Proposed Revision to Sargent & Lundy (S&L)
Topical Report SL-TR-1A
Quality Assurance (QA) Program

SARGENT & LUNDY LLC
NUCLEAR QUALITY ASSURANCE PROGRAM
TOPICAL REPORT
SL-TR-1A

REVISION 1516

Sargent & Lundy Management Organization Chart
Figure 01.01-1

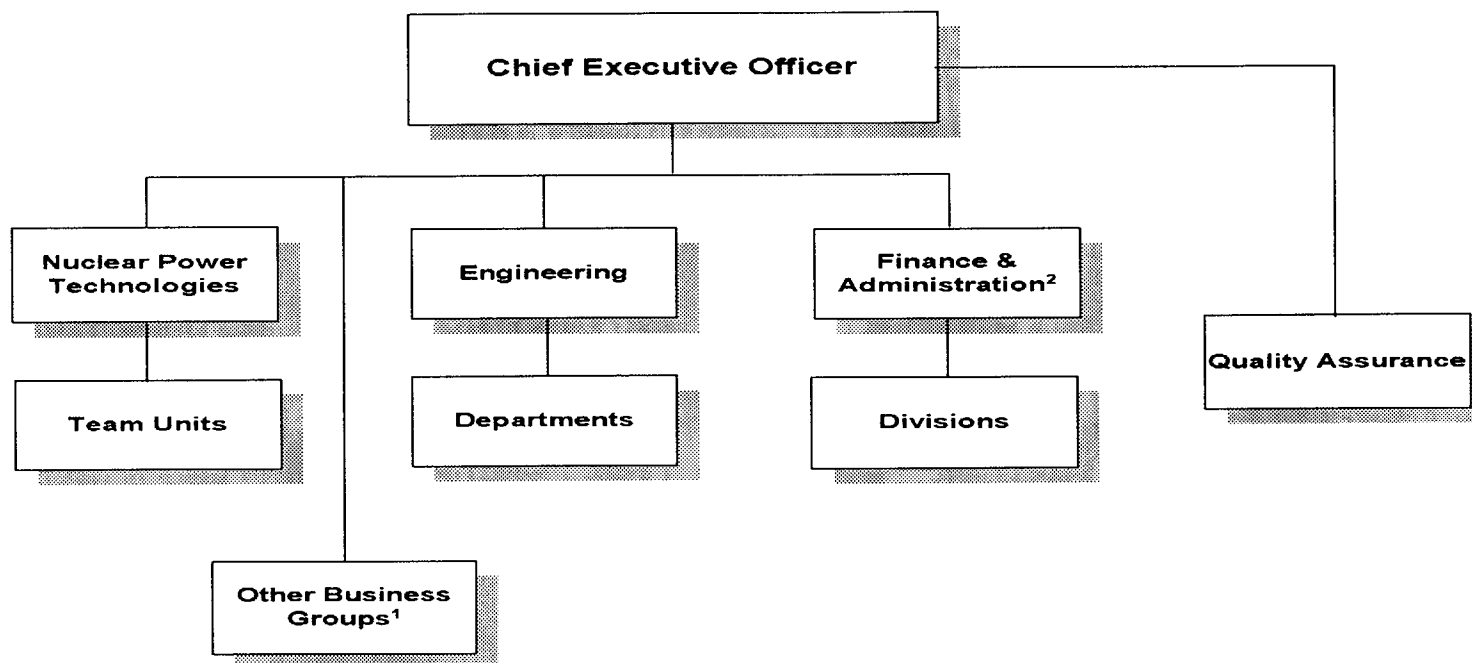
19 S&L's management organizational structure is shown in
20 Figure 01.01-1, Sargent & Lundy Management Organization
21 Chart. Company services are organized into three business
22 groups and two functional support groups. The business
23 groups are Nuclear Power Technologies Diversified
24 ~~Businesses and Management Consulting~~ and other business
25 groups as determined by the Chief Executive Officer. The
26 functional support groups are Engineering and Finance &
27 Administration. ~~Each group is managed by a Director who~~

1 ~~reports to~~ The Chief Executive Officer exercises
2 administrative control over the Directors of business
3 groups, as well as the Director of Engineering and the
4 Director of Finance & Administration. Although the
5 individual groups are distinct entities, the management and
6 execution of their respective functions and
7 responsibilities may involve staff sharing with other
8 groups.

12 ~~The Director of Diversified Businesses exercises~~
13 ~~administrative control over personnel and management~~
14 ~~resources providing information technology services,~~
15 ~~transmission and distribution services, and operations &~~
16 ~~maintenance services.~~

17 ~~The Director of Management Consulting oversees management~~
18 ~~consulting engagements that provide domestic government and~~
19 ~~industry association services. In a similar fashion, the~~
20 ~~Directors of the other business groups oversee services~~
21 ~~provided within their areas of responsibilities.~~

22 The Director of Engineering exercises administrative
23 control over the Engineering, Technical Support Staff, and
24 Material Management Departments.

1. (Section 01.01) The former Diversified Business Group and Management Consulting Group have been replaced. The only part of the Diversified Business Group that performed work under this program was Operations & Maintenance Services (OMS). OMS is now part of the Plant Support Services Department, which in turn is part of the Engineering Functional Support Group (see page 01-2 of Revision 16 of this program). The Consulting Group, which superceded the Management Consulting Group, performs work outside the scope of this program, such as due diligence studies.

3. (Section 01.01) The Engineering, Technical Support Staff, and Material Management Departments of the Engineering Functional Support Group have been replaced by the Project Services and Plant Support Services Departments. The responsibilities of the former three departments have been transferred to the new two departments with the additional responsibilities of OMS.
